SPRINGDALE SOLAR FARM

Further Request for Information (RFI) Report

Author	Steven Reid
Date	1 st October 2020
Ref	04317-1602908

Springdale Solar Farm - Operational Noise Contour Map

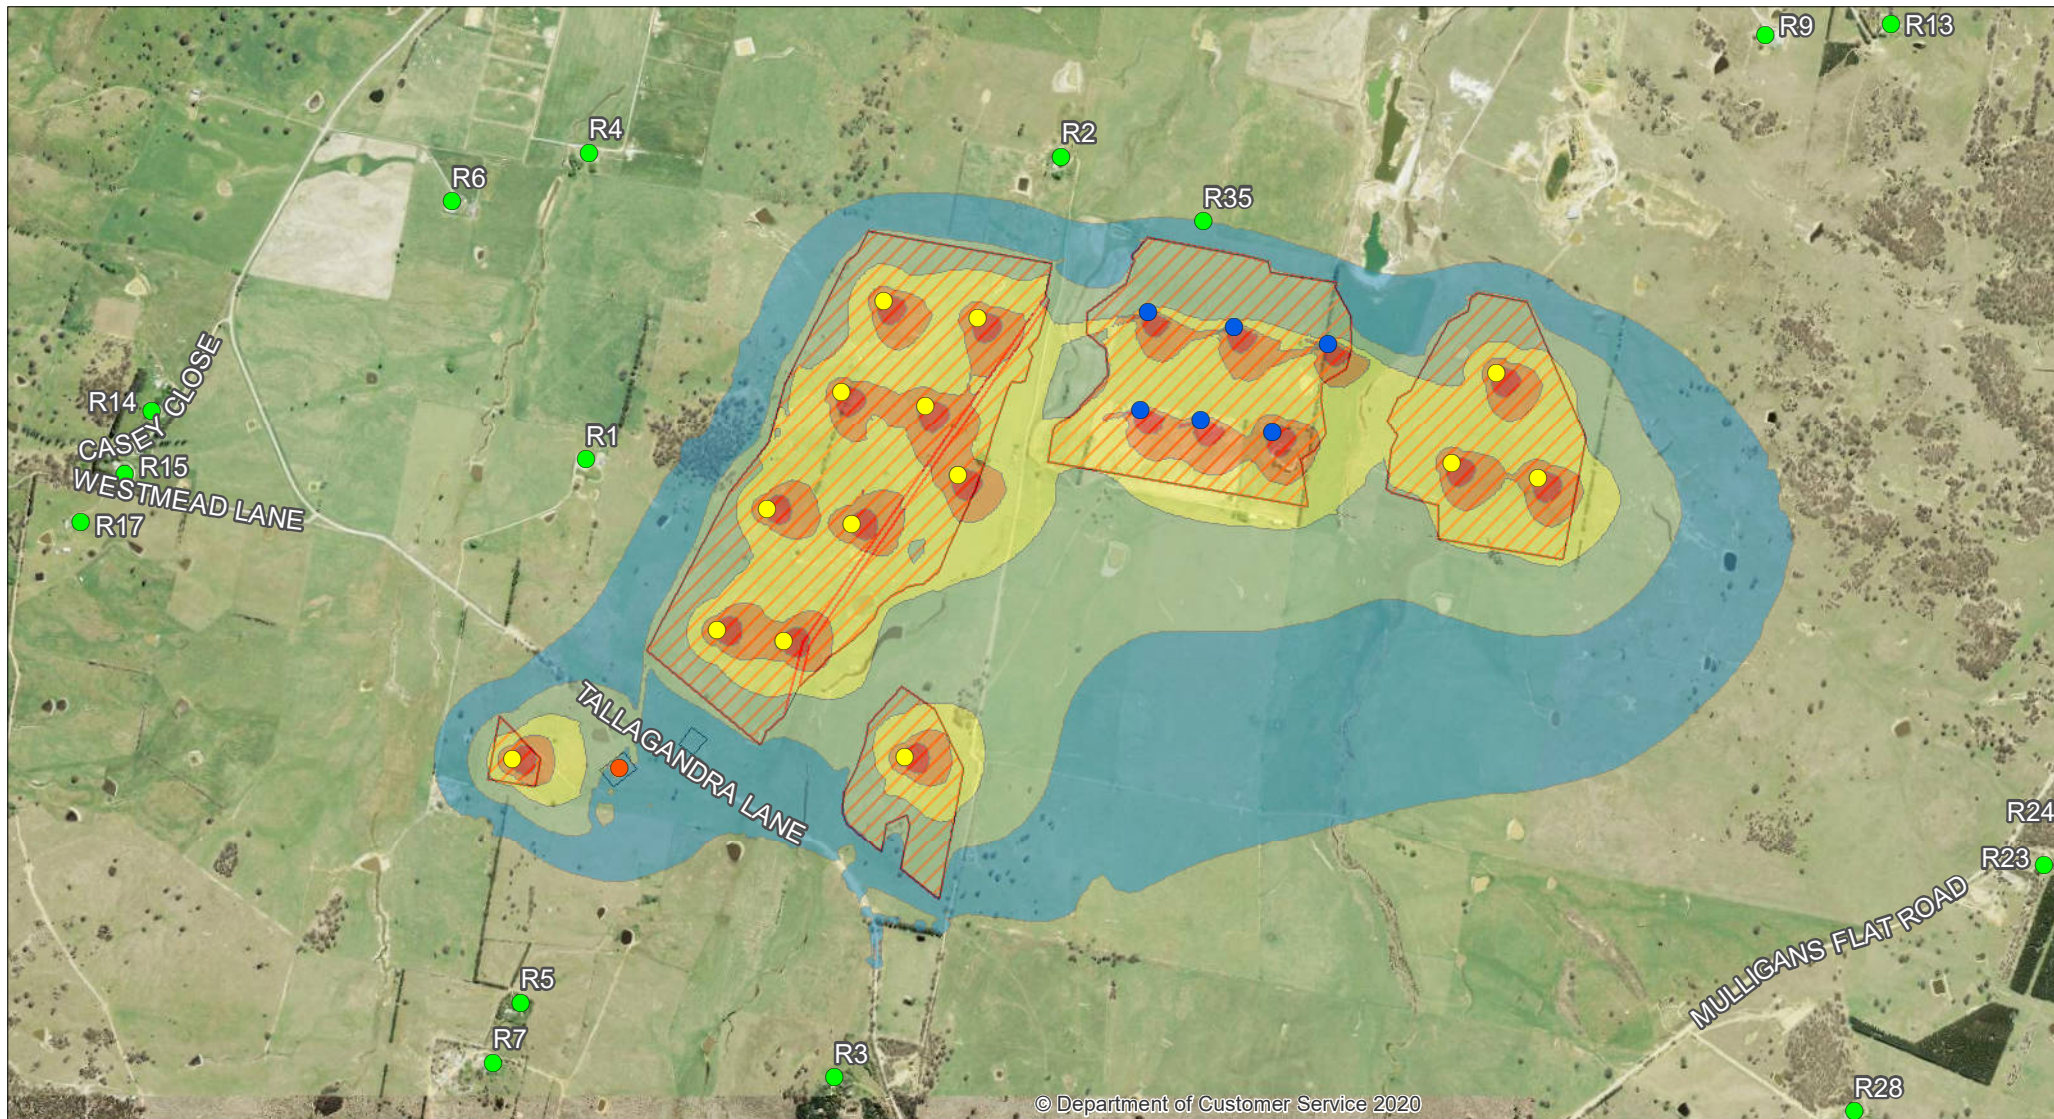
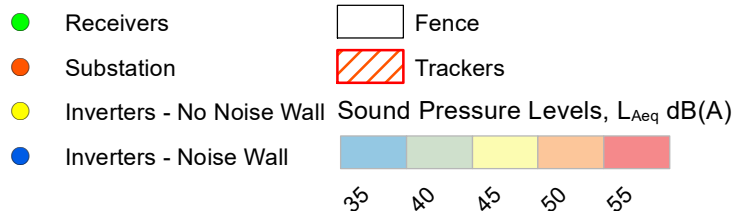
DPIE RFI	Proponent Response
<p>Assessment of noise and visual impacts on the newly erected building/dwelling located to the north of the project, as well as evidence of consultation undertaken with the landowner;</p>	<p>The proponent has met with the current owner of the new property located near the project's northern boundary. We have assigned this receiver with the next 'R' number from the noise assessment; R35. The noise assessment carried out by AECOM, as part of the original EIS, did not include this noise receiver for the obvious reason, it did not exist. The land on which R35 is located has since been subdivided by the former landowner and sold to a new owner, during the period the Springdale Solar Farm has been live in the State Significant Development process. All relevant information on the project's layout and noise impacts have been available to the general public.</p> <p>The proponent has updated the noise assessment with an addendum report See Annexure A. A different inverter and revised inverter location was adopted to mitigate the potential noise impacts at R35. The noise threshold of 35bd(A) is no longer exceeded for operational noise.</p>

Operational noise contours calculated at 1.5 m above ground are provided in the Appendix. These contours are indicative only and should not be referred to for noise levels at specific receiver locations. Operational noise levels and contours which are presented have been calculated under adverse weather conditions.

VISUAL RECEPTOR
VIEWSHED

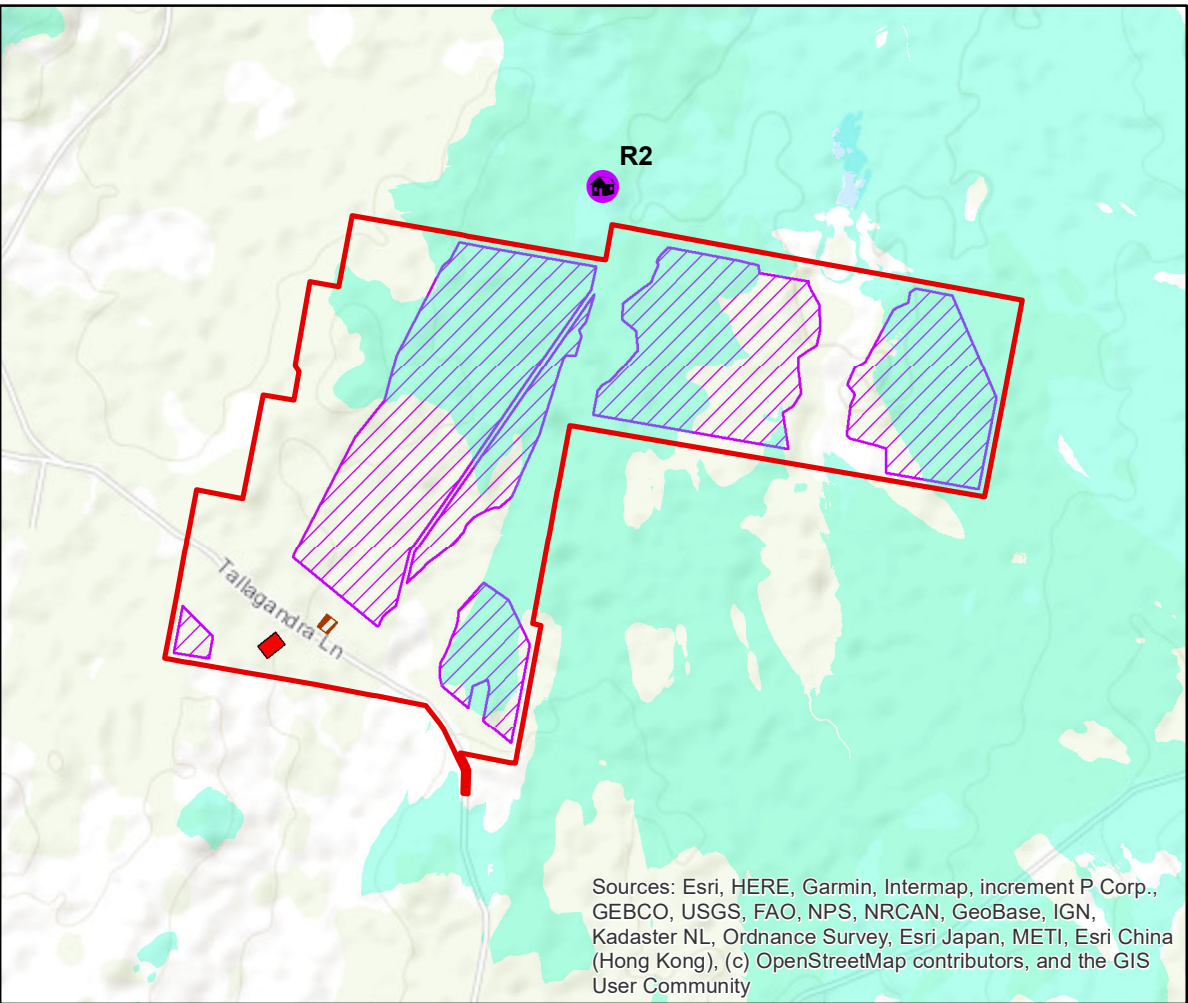
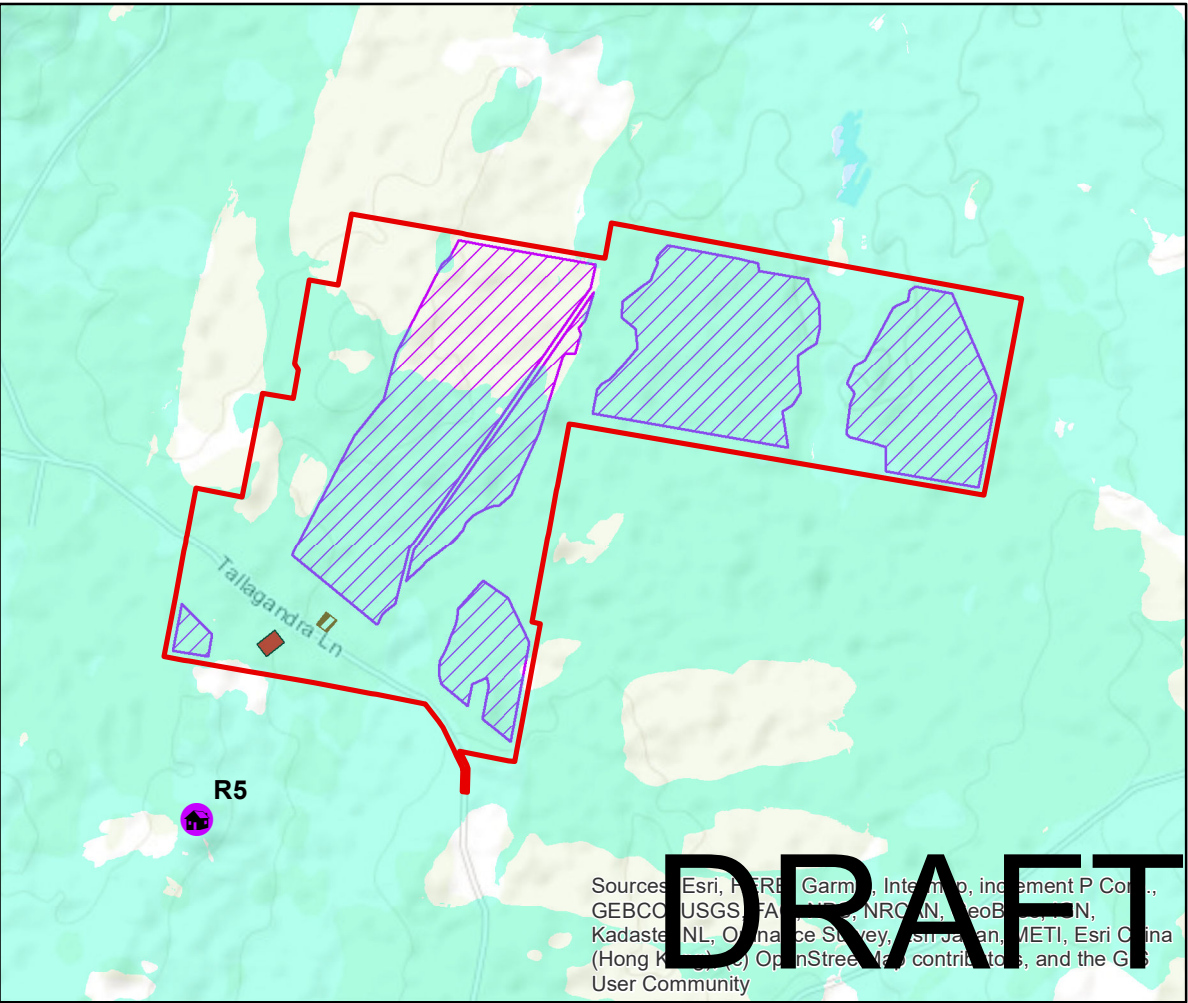
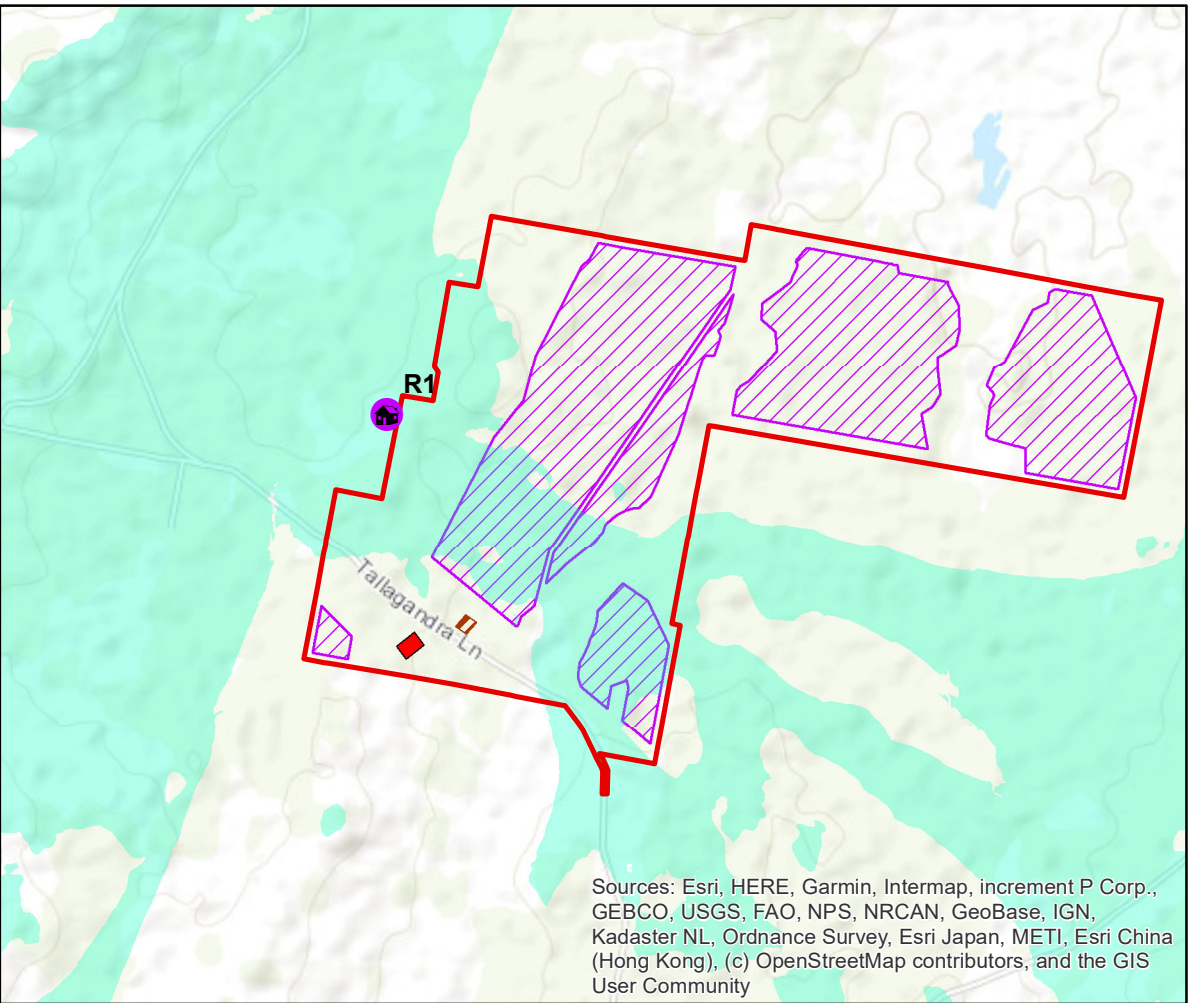
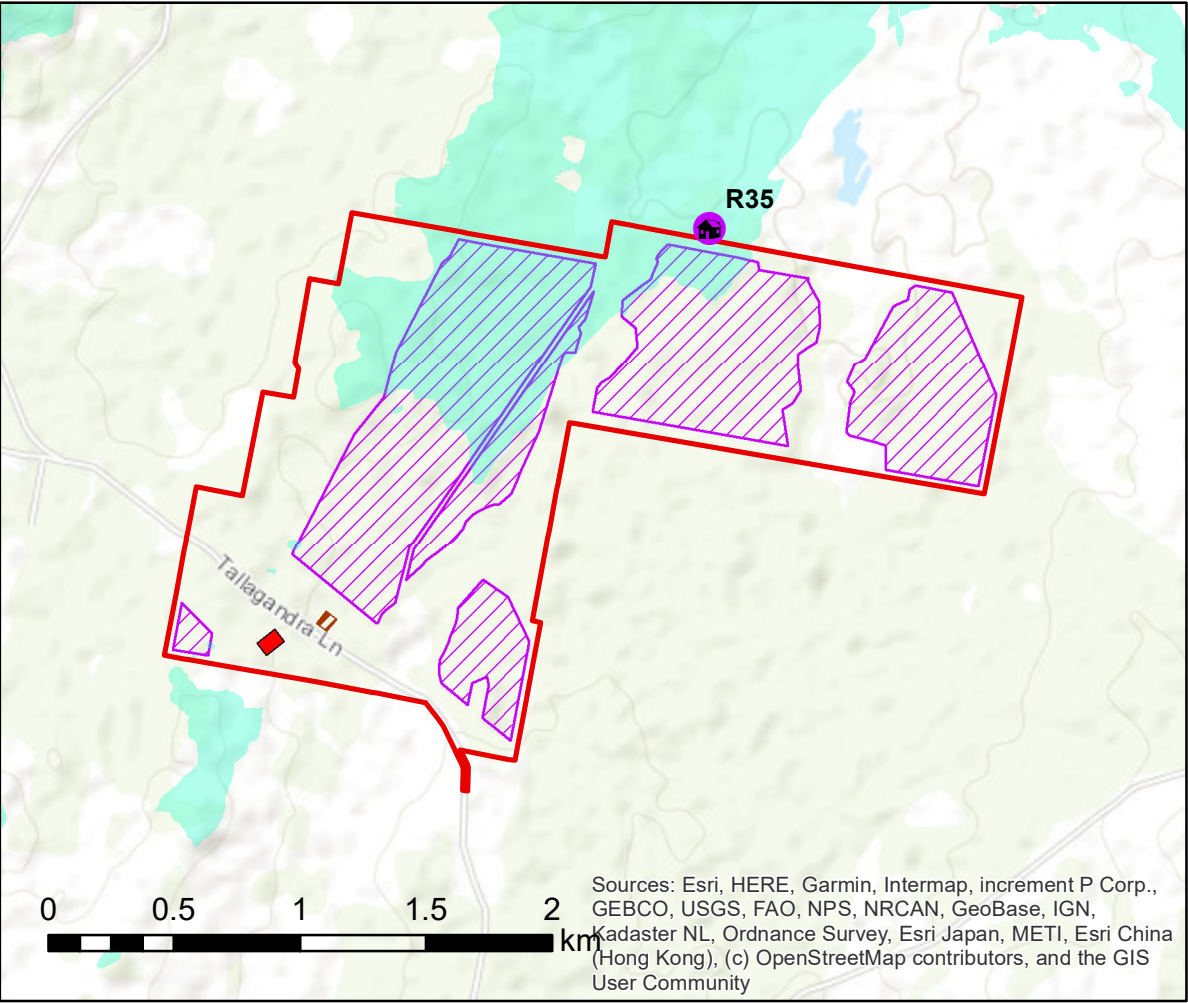
Provide viewsheds from R1, R2, R5 and new dwelling, and confirmation that the Visual Envelope Map in the LVIA is modelled based on topography alone, and not taking intervening vegetation into consideration;	<p>AECOM have confirmed that Figure 2 (Visual envelope map) within the Landscape and Visual Addendum is a zone of theoretical visibility (ZTV) of the project taken at 1.7 metre eye height, with a 2 km range from the perimeter of the solar farm applied. That is, areas that are not shaded on the map are either outside the 2 km buffer or have their view of the solar farm obstructed by the natural topography (from an eye height of 1.7 m). Screening by intervening vegetation was not considered when preparing this map.</p> <p>Viewsheds have been provided for all 4 requested receptors and are included at Annexure B</p>
Updates to the Main Constraints map:	
Label residences as per Noise Impact Assessment numbering (eg Gillett is R1, Hassall is R2 etc);	Completed, see revised Constraints plan at Annexure C.
